C/ 00 SC	Р	L	# 54	C/ 00	SC		Р	L	# 176
Thaler, Pat				Geoff Thom	pson		Nortel		
state requirements Must is best avoid SuggestedRemedy	Itiple places in the draft. In IEE	ate an inevitable cc	onsequence.	The res "The lir are ISC frequer	ent 584 olution k segm /IEC 1 cy up t	nent tran 1801 Cla o 500 M	Comment Status A 2.0 nent text: smission parameters of insert ass E specifications extended Hz with appropriate adjustmer R-24750 and TIA/EIA TSB-15	by extrapolatir nts for length v	ng the formulas to a
page 16, line 13, c page 18, line 52, c page 71, line 54, c page 75, line 29, c page 75, line 32, c page 75, line 35, c page 91, line 31, c page 107, line 44, page 107, line 44, page 107, line 48, page 107, line 50,	<i>Response Status</i> C CIPLE. 28.2.3.4.14: Leave as is (consistent of the state of	erate" to "operates" erate" to "operates" erate" to "operates" et" to "sets"	:2005)	Suppor specifie Suggested Select develop Proposed F ACCEF 802.3a This ac the sup ISO/IE0	ts my o d by in Remedy copper bed thro Respons T IN P n will co tive coo port of C 1180 ⁻	riginal p ternatior media fr bugh wor se RINCIPL ontinue to ordinatio 10GBAS 1 (ED.2.0	al standard available nor is the oint that we a

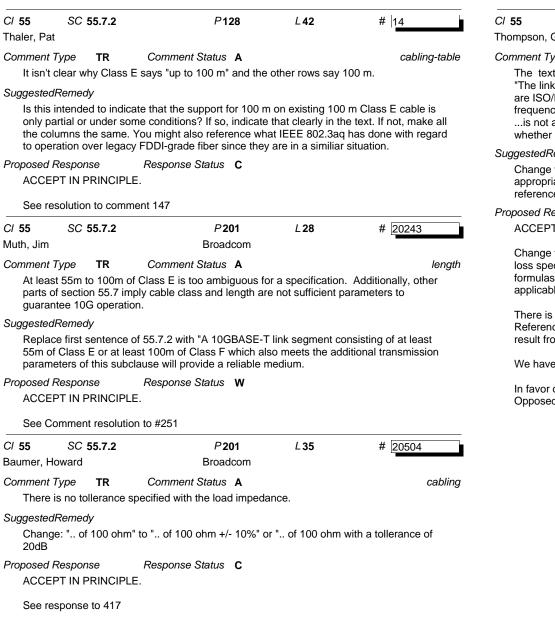
Cabling Ali	en Crosstalk	Max Ca	bling
Mitig	ation Distar	ice Referen	ces
Class E screened	not required	100m IS	SO/IEC TR-24750
Class E unscreened	not required	55m (TBD)	ISO/IEC TR-24750
Cat 6 unscreened	not required	55m (TBD)	TIA/EIA TSB-155
Class E unscreened	required	100m IS	SO/IEC TR-24750
Cat 6 unscreened	required	100m Tl/	VEIA TSB-155
Class F (screened)	not required	100m IS	SO/IEC TR-24750
new Class E unscreenee	d not require	ed 100m	ISO/IEC 11801 Ed 2.1
Cat 6 Augmented (unsci	eened) not requ	uired 100r	n TIA/EIA-568-B.2-10

ACCEPT IN PRINCIPLE.

Motion to: Add a row to Table 55-10 with Class E screened for 100m referencing ISO/IEC TR24750

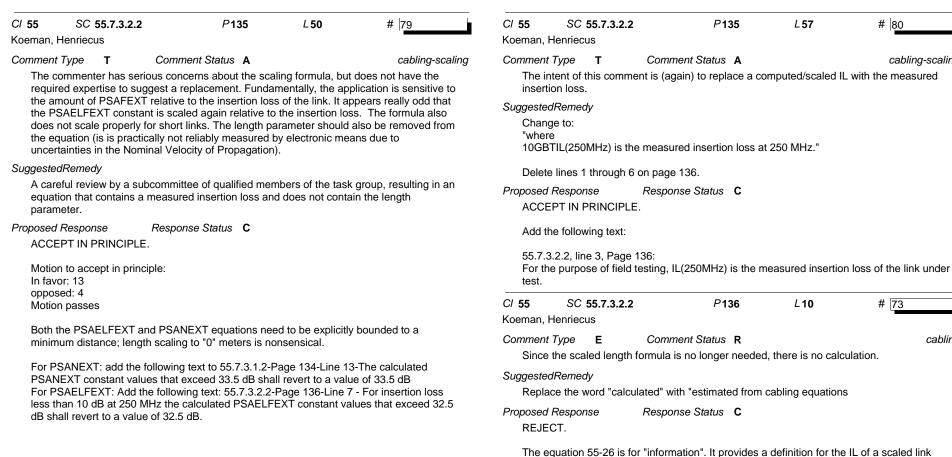
The scaling of PSAELFEXT only applies to the channel whose length is between 55m and 100m.

Proposed Response Response Status C REJECT.

The scaling problem for distances below 55m has been addressed by the response to comment 79
